March 6, 2015

SUBJECT: Invitation for Bid #15-0382DC
Supervisor of Elections Phases 2 and 3

ADDENDUM #3

E5.2

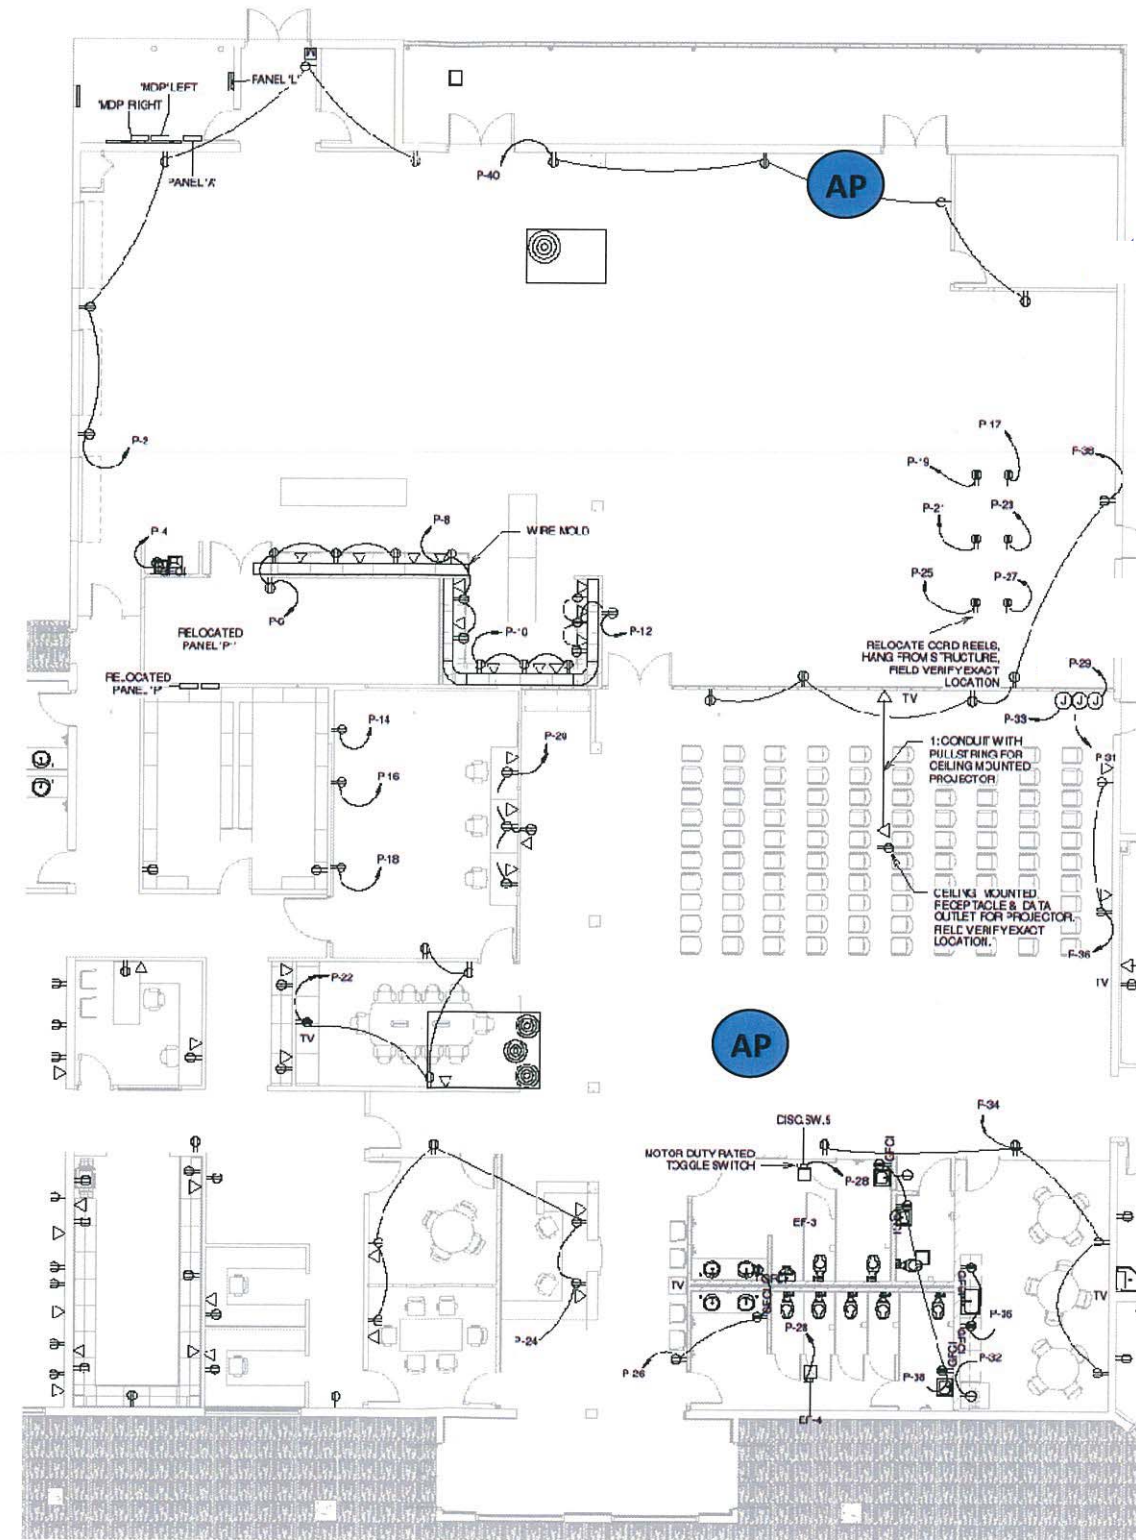
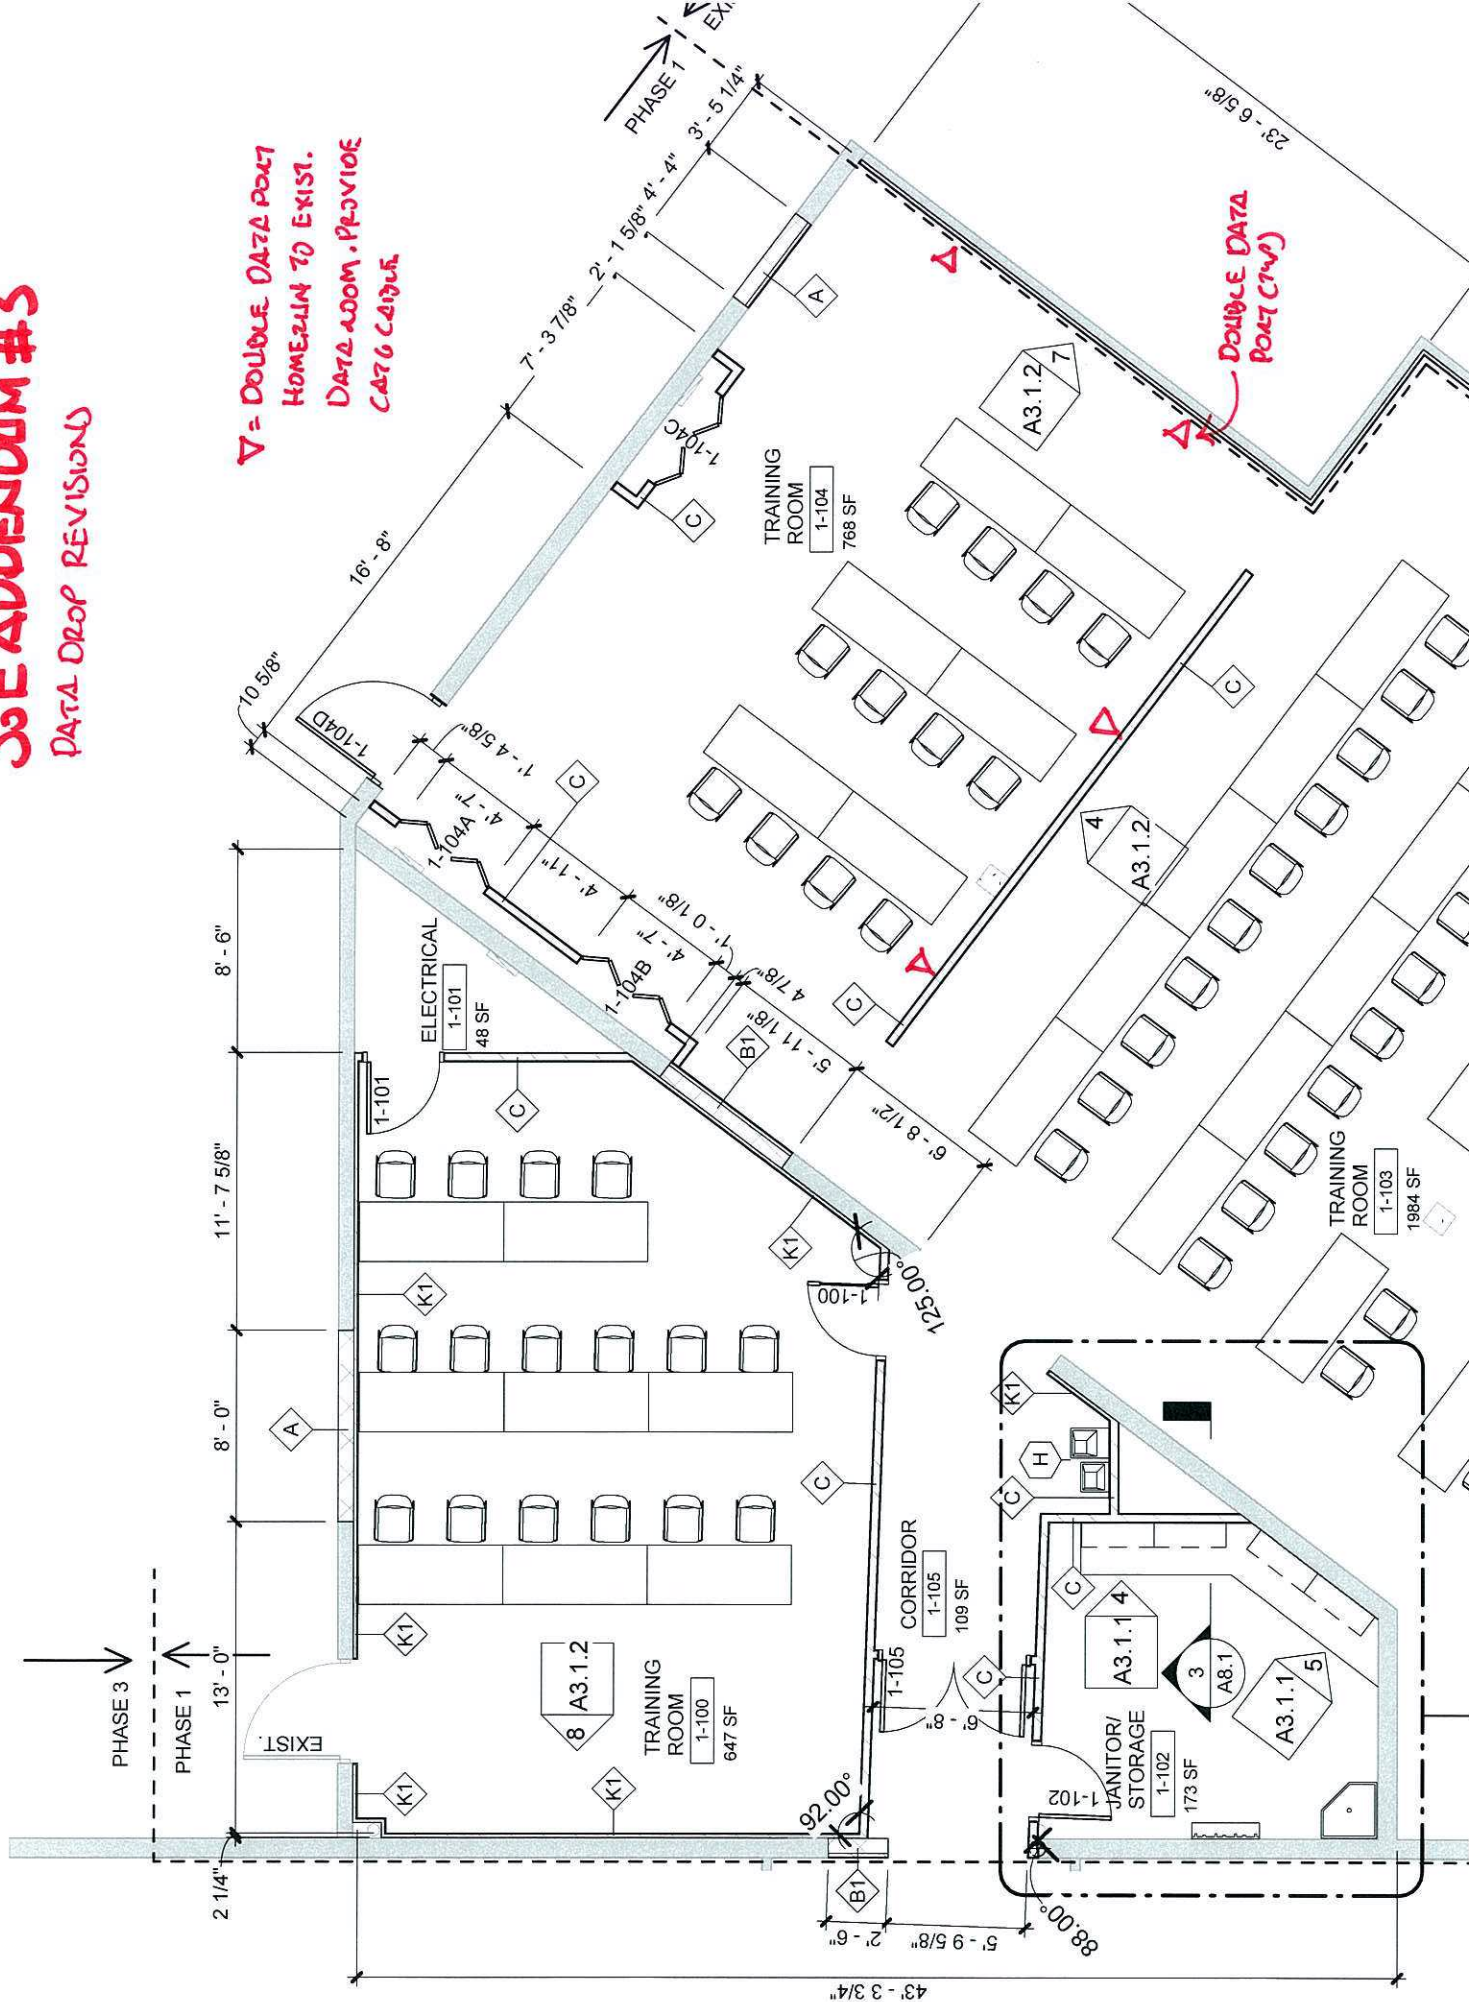
8. Verify which panel is feeding panel W1 (this is being replace and panel LP is being installed) Capturing feeder from existing W1 and relocating this is impossible; we will have to run conduit over head from source to panel LP new location and pull new wiring. **Response:** During design, it was determined that W1 was fed overhead. Review of site pictures shows main circuit breaker at bottom of panel. This panel may be bottom fed from slab. The Contractor bid shall include a new 200A/4-wire overhead feed from outside MDP to new Panel LP location, demolition of existing feed down to the slab, and removal of conductors back to source. The existing source of Panel W1 shall be determined during construction phase.

13. Drawing E5.2 states to "capture & extend..." however capturing feeder from existing W1 and relocating this is not possible since it is fed from underground; we will have to run conduit overhead from source to panel LP new location and pull new wiring. Please verify which panel is feeding panel W1 (this is being replace and panel LP is being installed) and which panel is feeding panel LP? **Response:** During design, it was determined Panel W1 is fed from the MDP outside the East wall of Phase III (overhead). Site pictures shows main circuit breaker at bottom of panel; this panel may be bottom fed from slab. Bids shall include a new 200A/4-wire overhead feed from outside MDP to new Panel LP location, demolition of existing feed down to the slab, and removal of conductors back to source.

DATA DROP REVISIONS

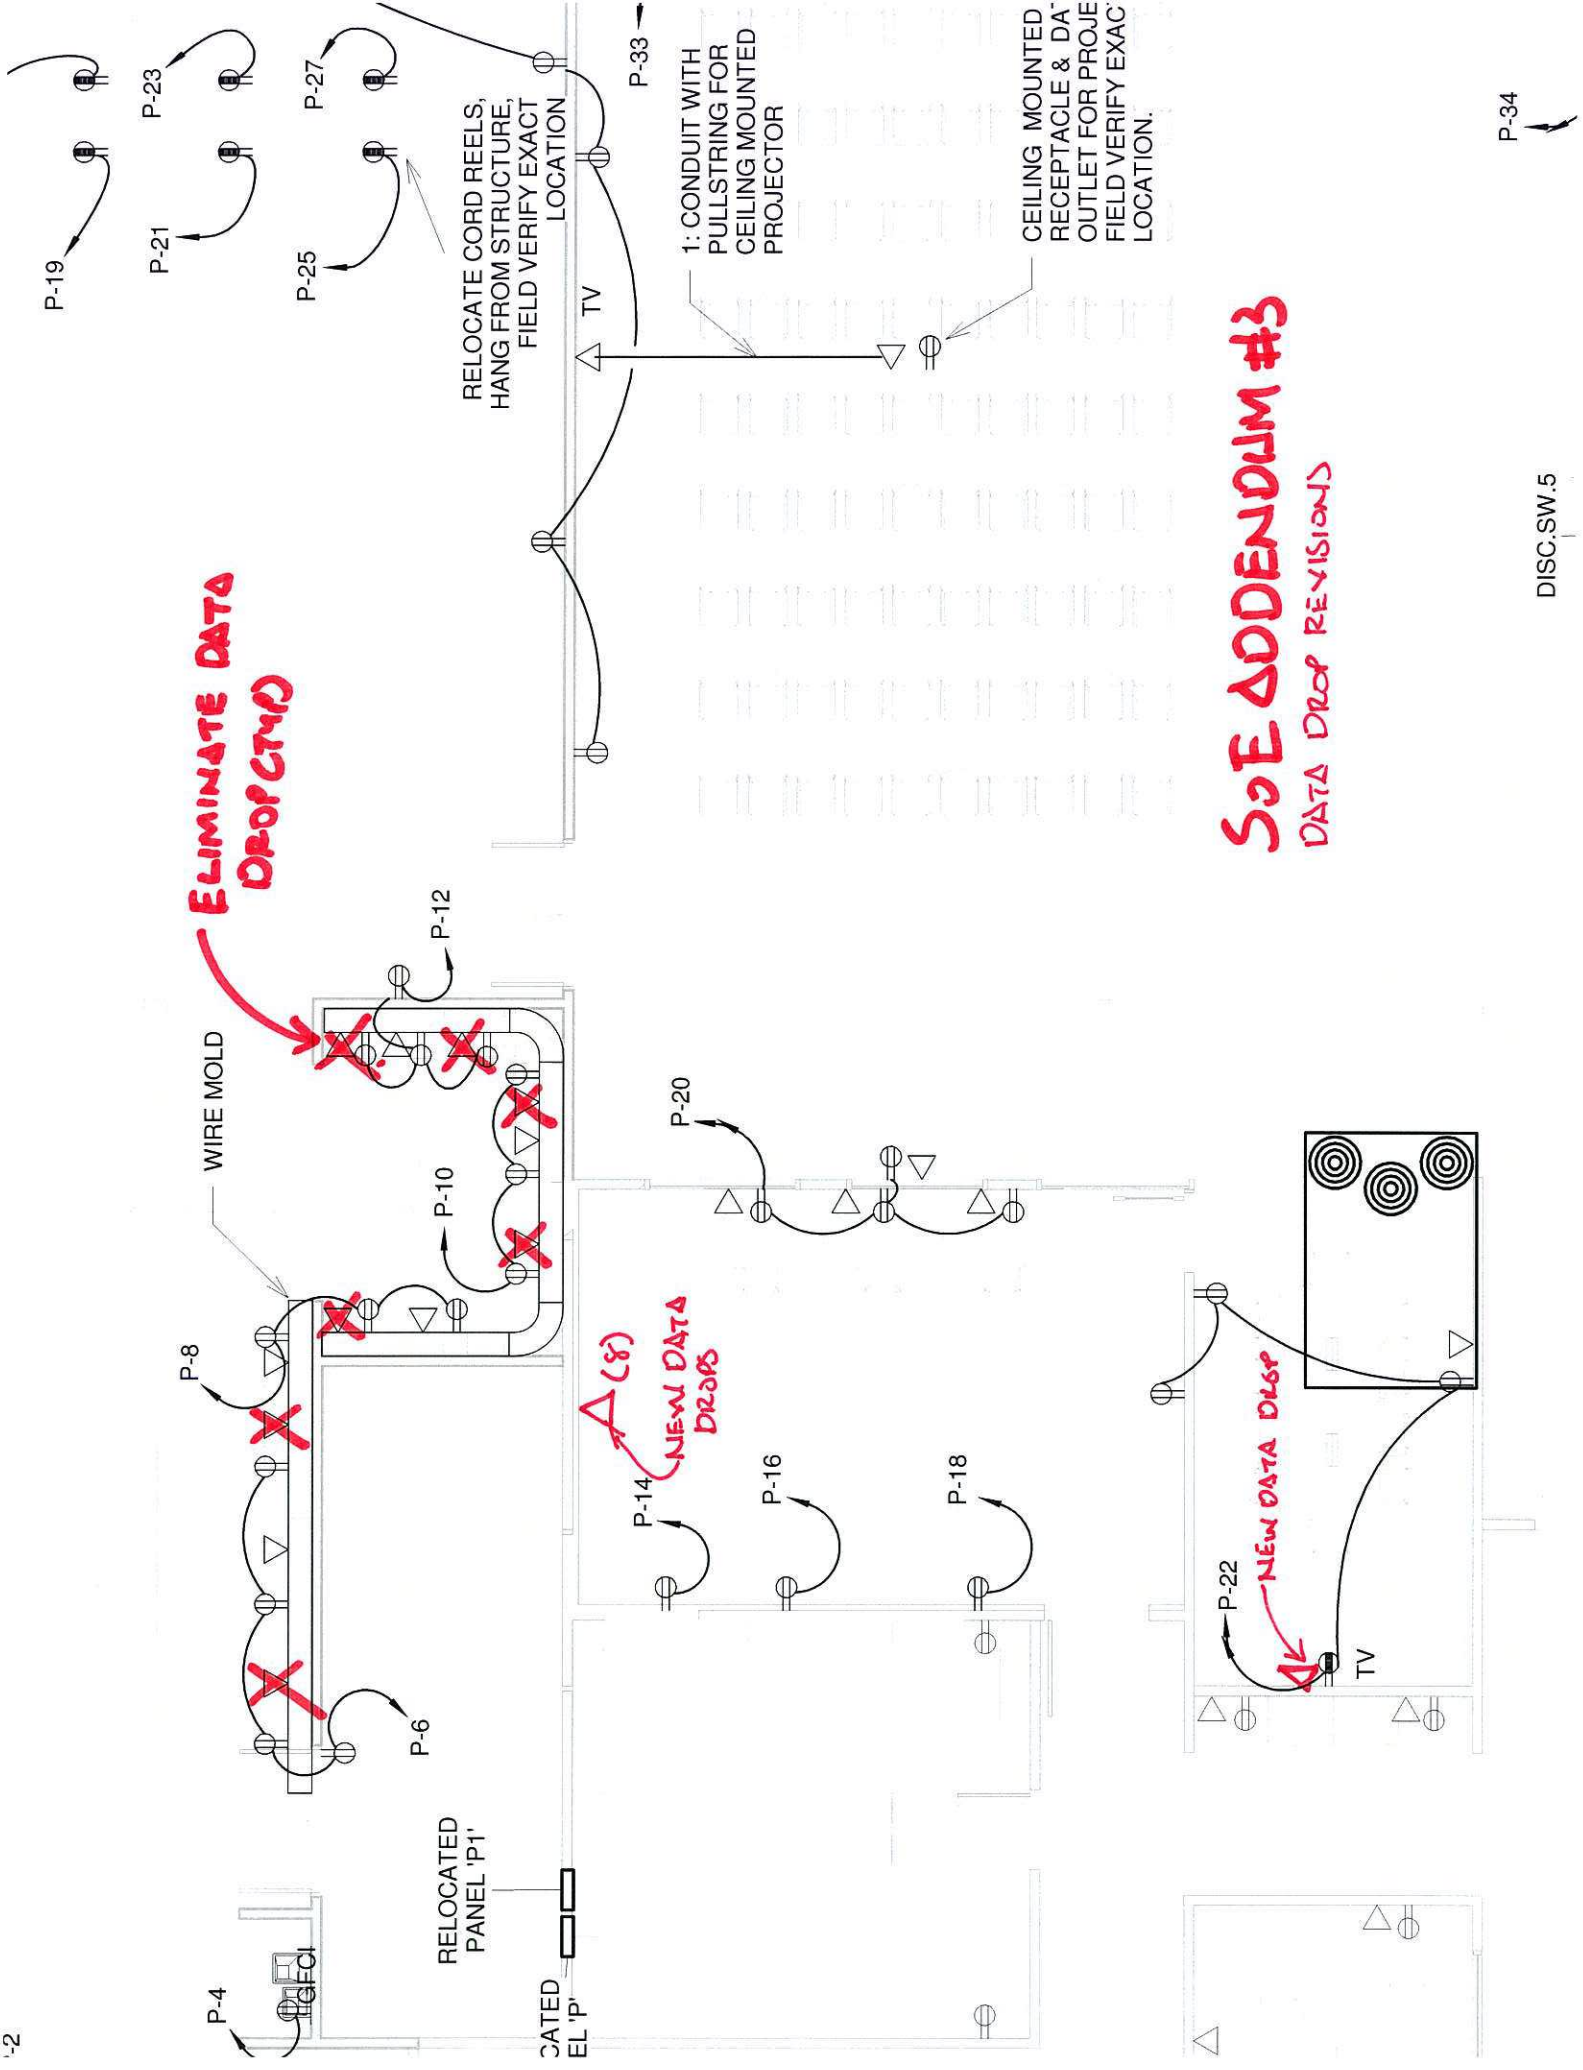
- a. Eight Cat 6 data lines terminating to 4 double boxes in the completed Phase 1 section shall be added to the project, see attached Sketch for location.
- b. The storage area data drops have been revised to eliminate 7 drop locations to be relocated.
- c. The Vote Tabulation room shall have 8 data drops as shown on the plan.
- d. A data drop shall be located at the monitor location in the conference area (specified on the attached Sketch).
